Planning Commission Meeting
Thursday, November 13, 2014
Meeting held at the Saratoga Springs City Offices
1307 North Commerce Drive, Suite 200, Saratoga Springs

Planning Commission Staff Report

Preliminary Plat Heron Hills October 13, 2014 Public Hearing

**Riverbend Townhomes
Site Plan, Preliminary Plat, MDA Amendment
Thursday, November 13, 2014
Public Hearing**

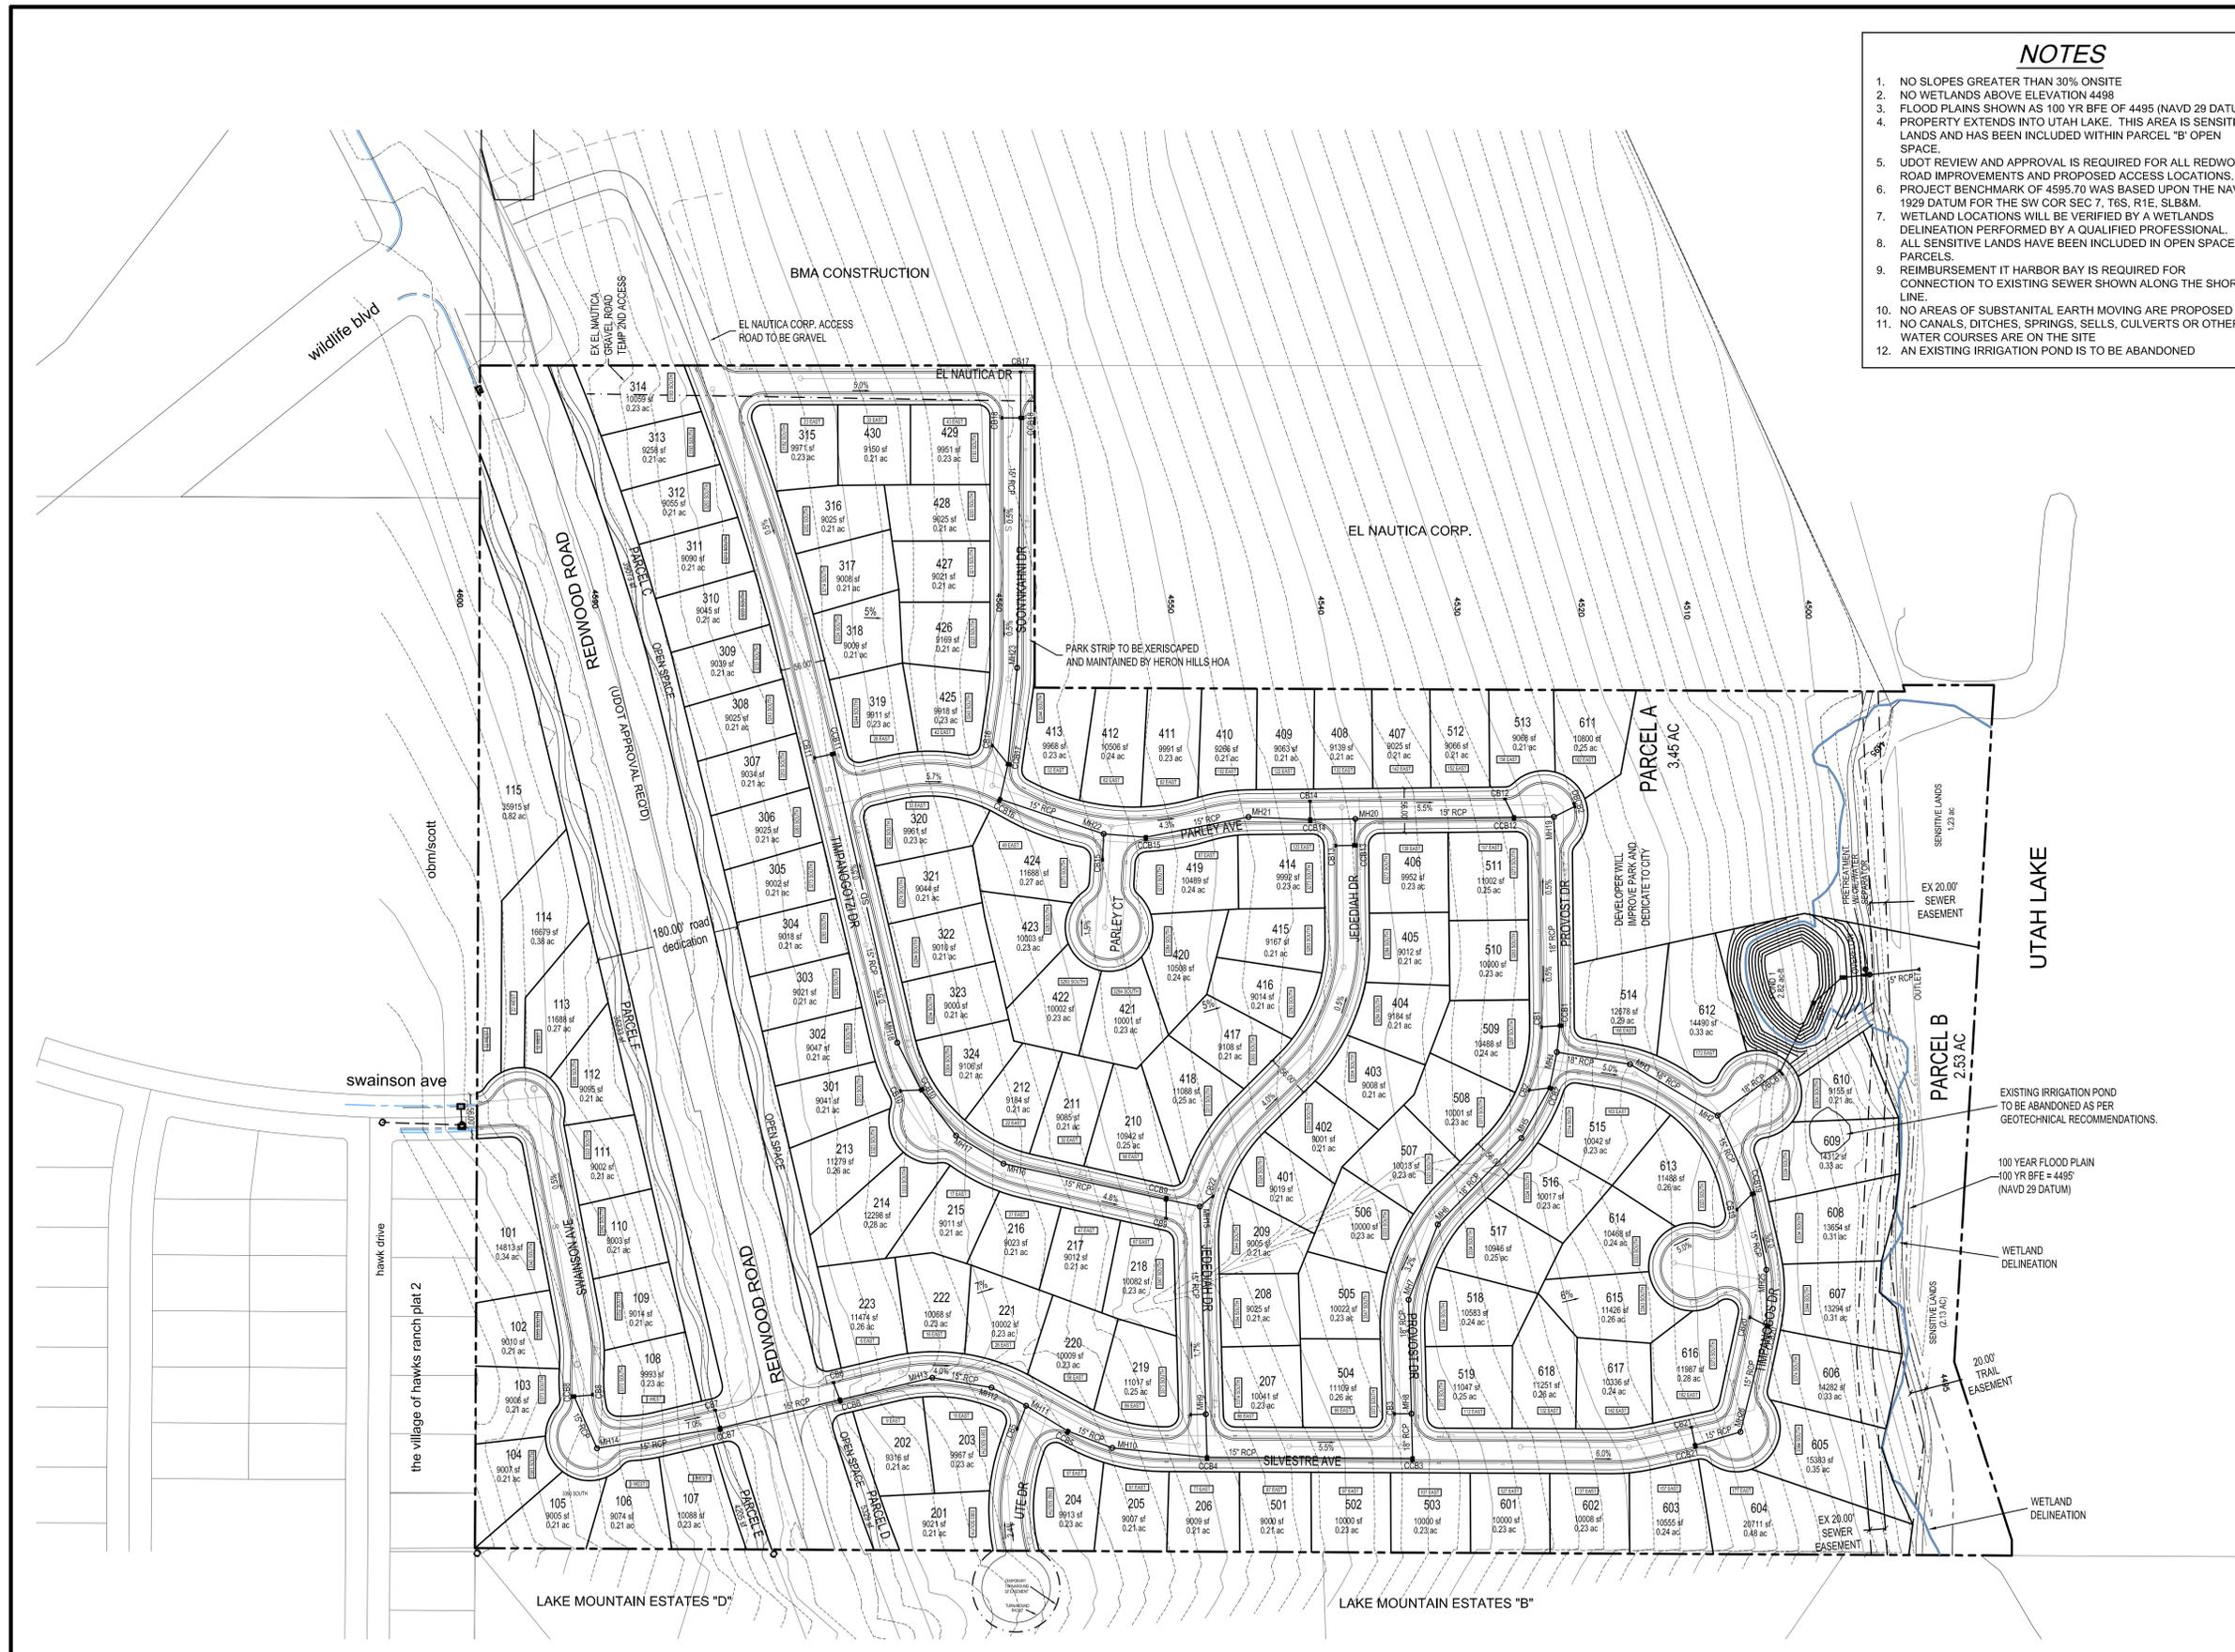
The Planning Commission reviewed the proposed preliminary plat on October 23, 2014. At that meeting concern was expressed by members of the El Nautica Boat Club regarding the realignment of the access to El Nautica and regarding property line issues between the El Nautica Corp property and the Old Town Square LC property (Heron Hills). The Planning Commission tabled the application to allow the applicant to address these issues and to update the street names on the plans.

Since that meeting the applicant has revised the plan and proposes to leave the access to El Nautica boat club as it is. This results in a different lot configuration in the northwest corner of the project.

PHASING PLAN **C1**

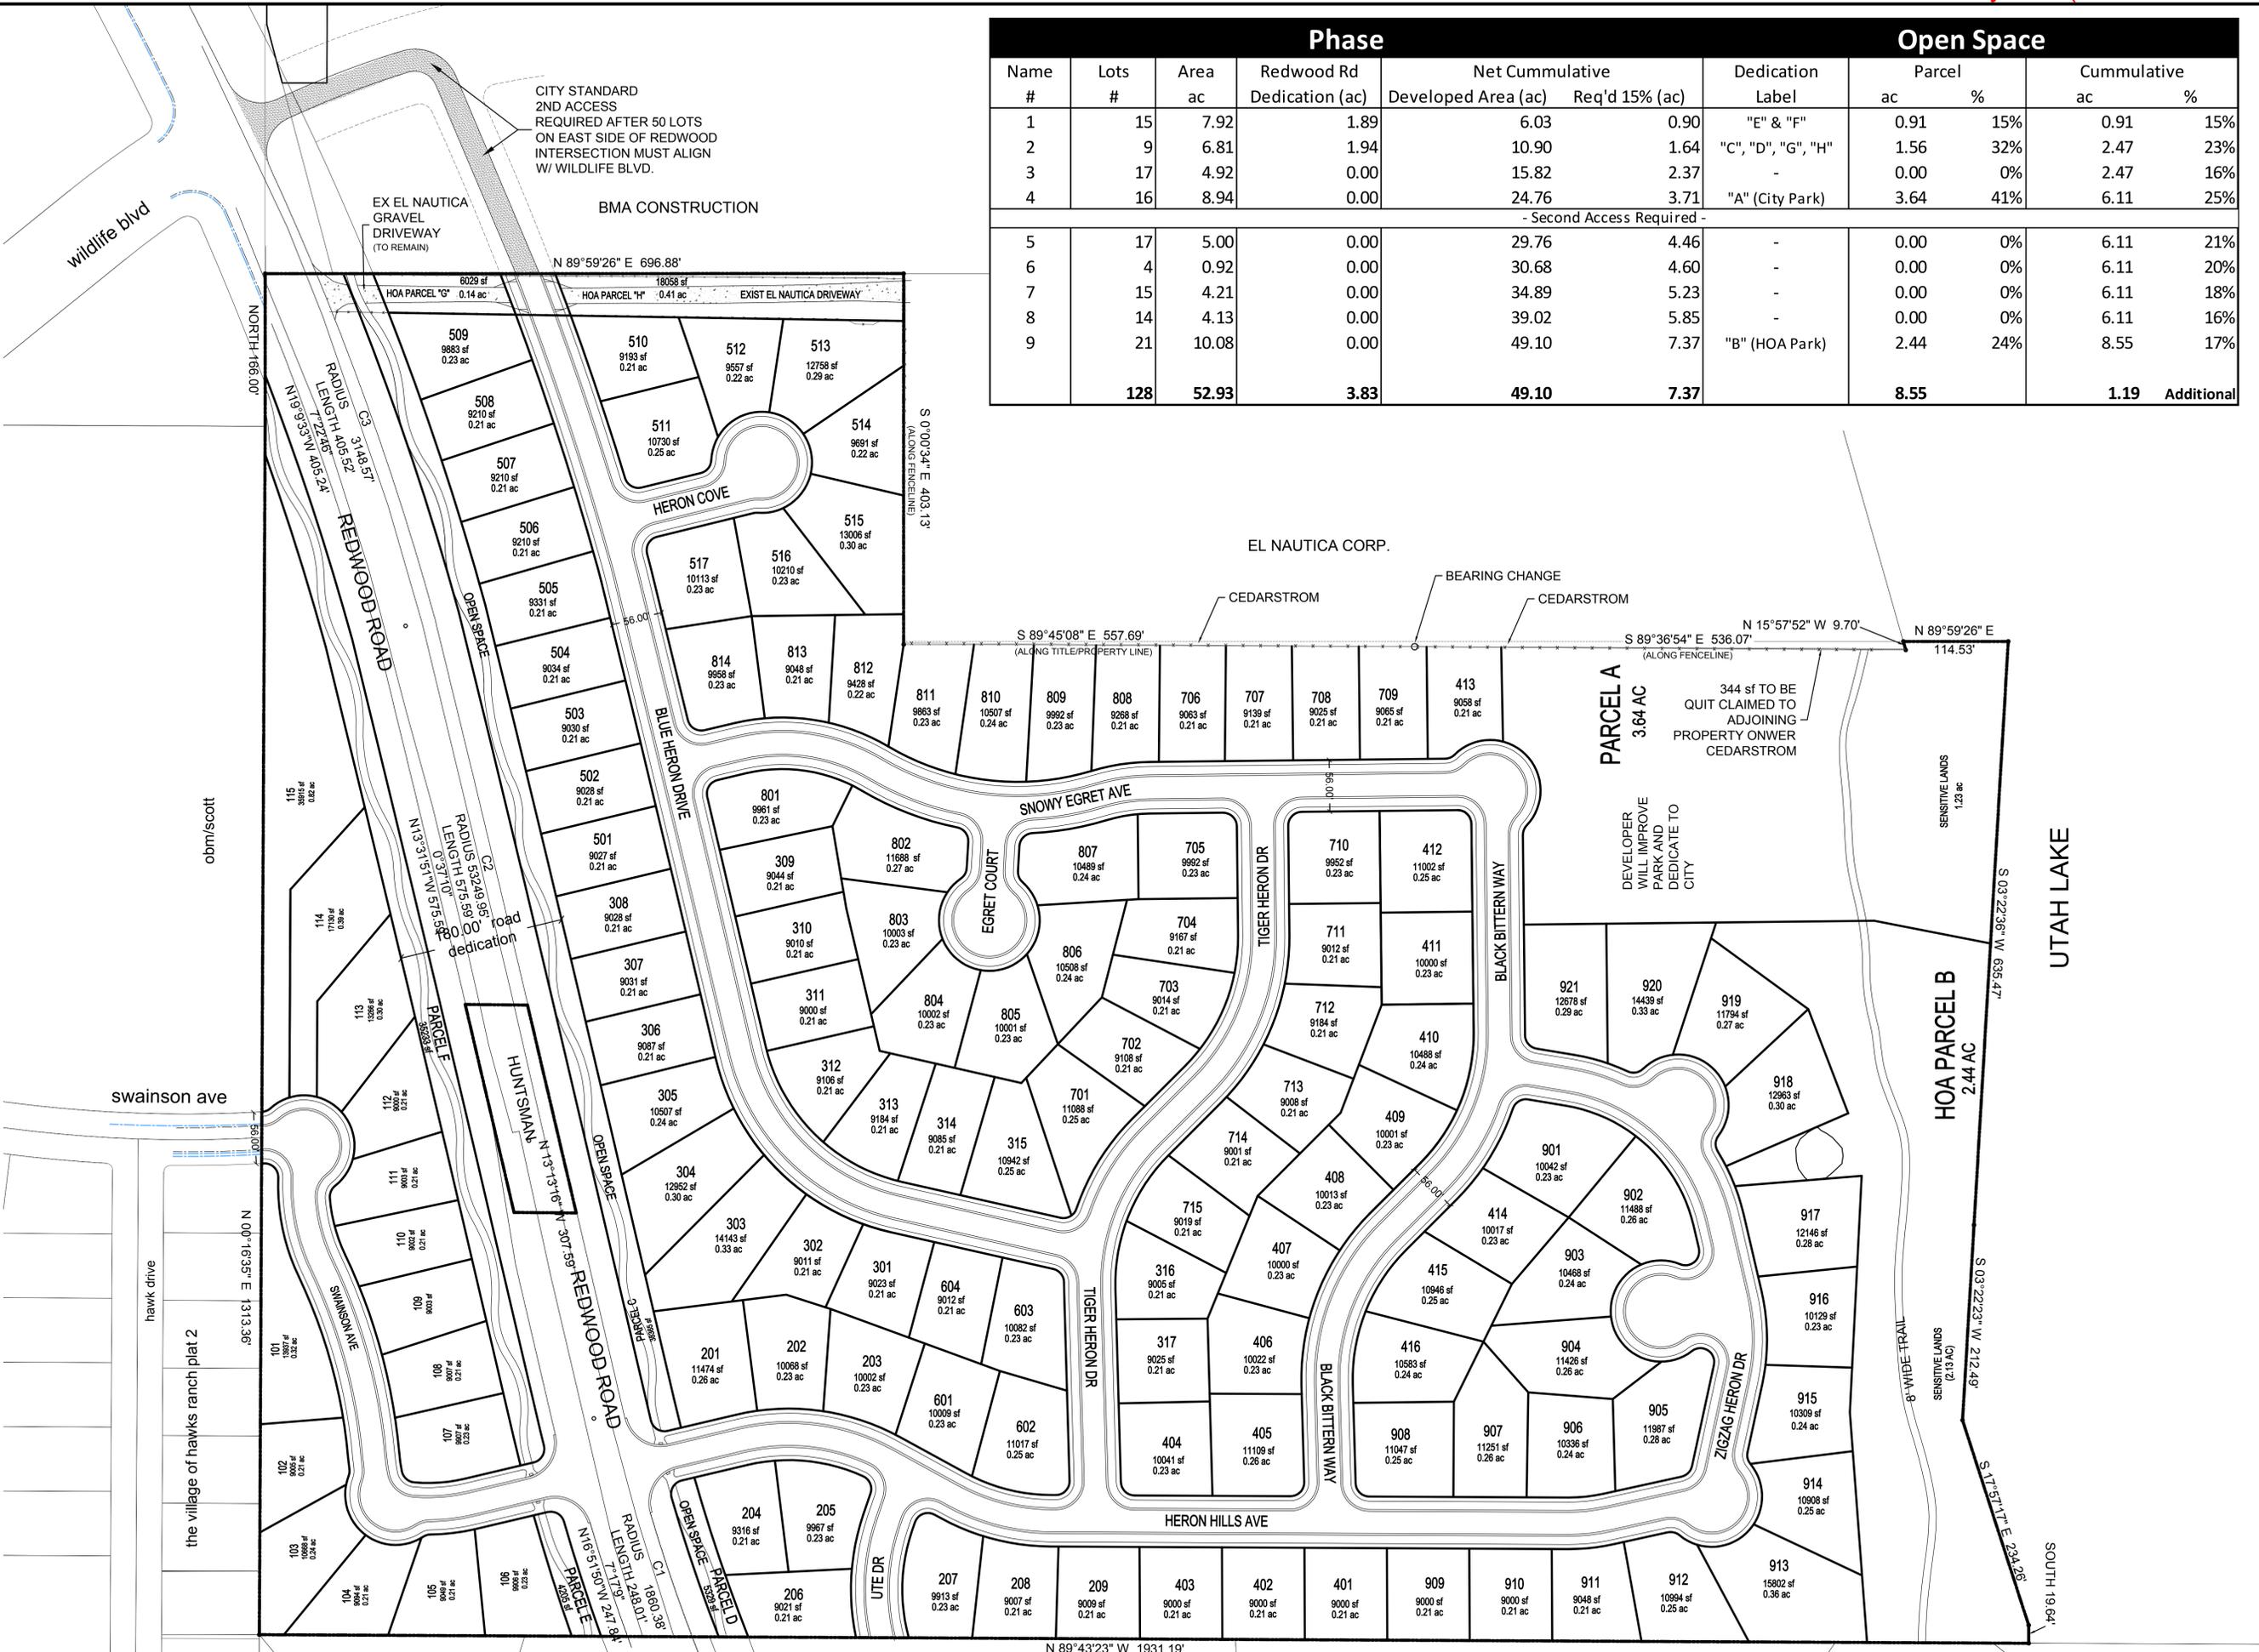
Phasing plan: does not comply. Section 19.12.02 (6) requires that when a development is proposed to occur in stages, then the open space or recreational facilities shall be developed in proportion to the number of dwellings intended to be developed during any stage of construction.

The Council may wish to discuss the phasing plan. Phases 1, 2 and 3 include portions of the Redwood Road trail and the public park is proposed with Phase 2. However, no access to the park is provided with Phase 2. Because Parcel B is generally for the benefit of the lot owners near the lake and will remain in a native condition, it is not necessary to dedicate this land prior to the development of the surrounding lots. However, the phasing plan should be reconsidered to meet this code requirement and so that access is provided to the park with Phase 2 or 3. Staff recommends that the applicant submit a revised phasing plan

6. The detention basin shall be located in the HOA open space area and not in the future City park.
7. The phasing plan shall be revised to meet the requirements of Land Development Code Section 19.12.02 (6) and shall be submitted with the first final plat application and shall be approved by the City Council prior to approval of the first final plat.
